Amendment of the Bay-Delta Water Quality Control Plan's Compliance and Baseline Monitoring Program

Presented to the State Water Resources Control Board
By Stephen Ford (DWR) and Erwin Van Nieuwenhuysse (Reclamation)
October 27, 2004

Figure 3: Comparison of Hood and Greens Landing Monitoring Stations

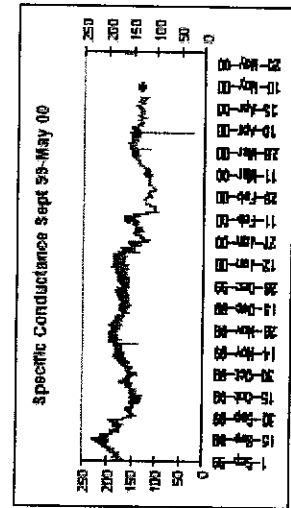
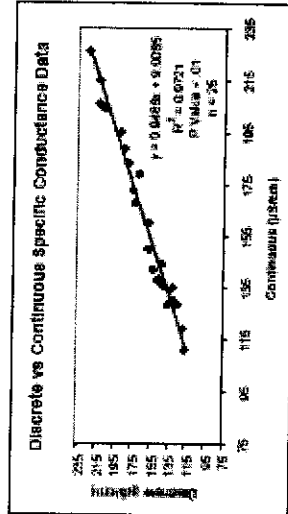
- 17 monitoring elements would remain unchanged
- 4 monitoring elements would remain operationally unchanged but would be identified with new station numbers
- 8 historically monitored elements would be reestablished
- 8 historically monitored elements would be removed
- 8 baseline monitoring elements would be added
- 2 baseline monitoring elements would be moved to consolidate two neighboring stations (Hood & Greens Landing) for greater sampling

efficiency. Comparisons of monitoring data from these two stations show no differences (Figure 3 of this document).

Figure 4: Proposed Revision of Figure 2 of the 1995 Bay-Delta Water Quality Control Plan

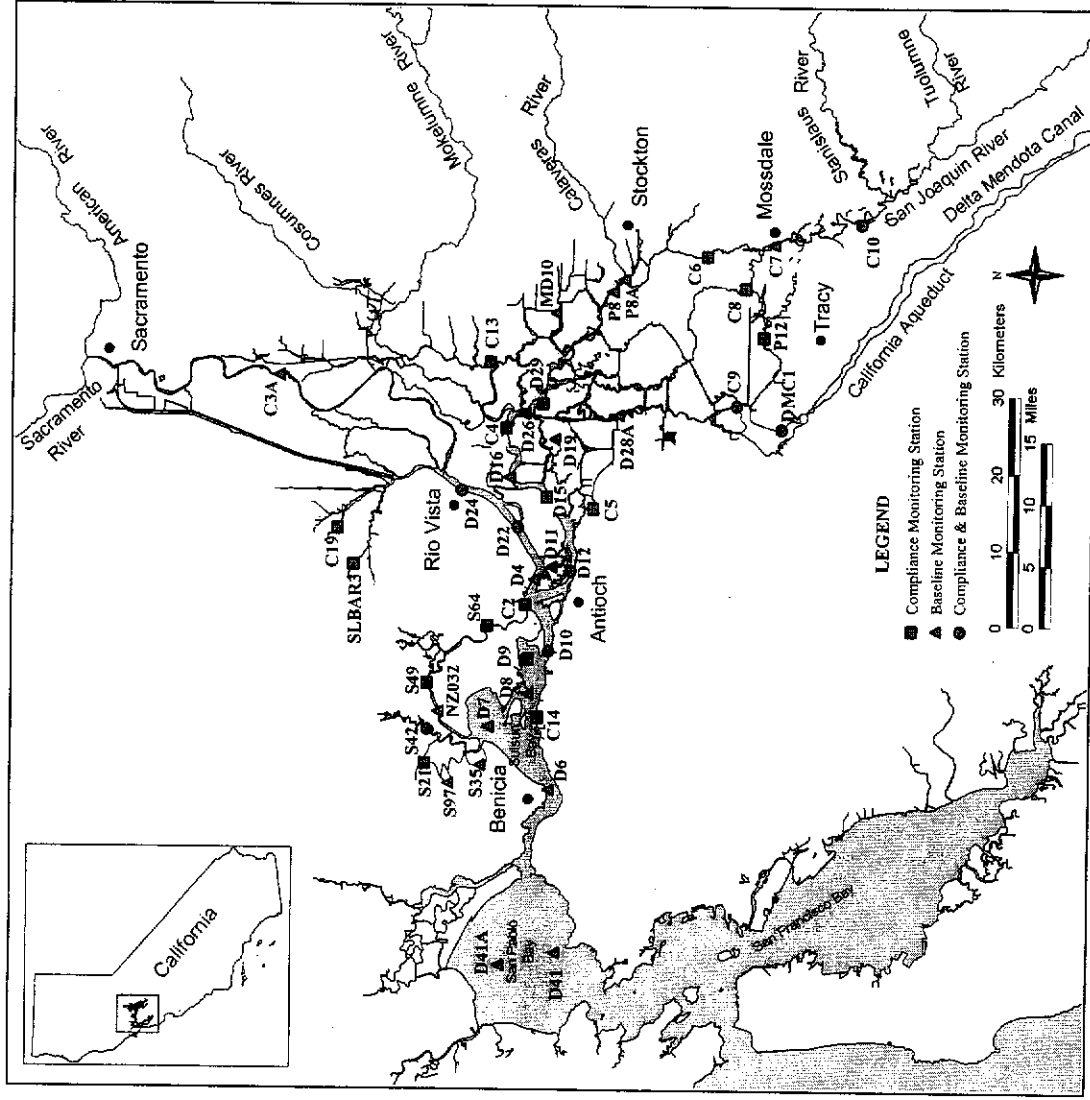
The amendment of Figure 2 of the Plan would reflect the previously proposed changes to the monitoring plan. Figure 4 of this document shows the proposed revision of the Plan's Figure 2.
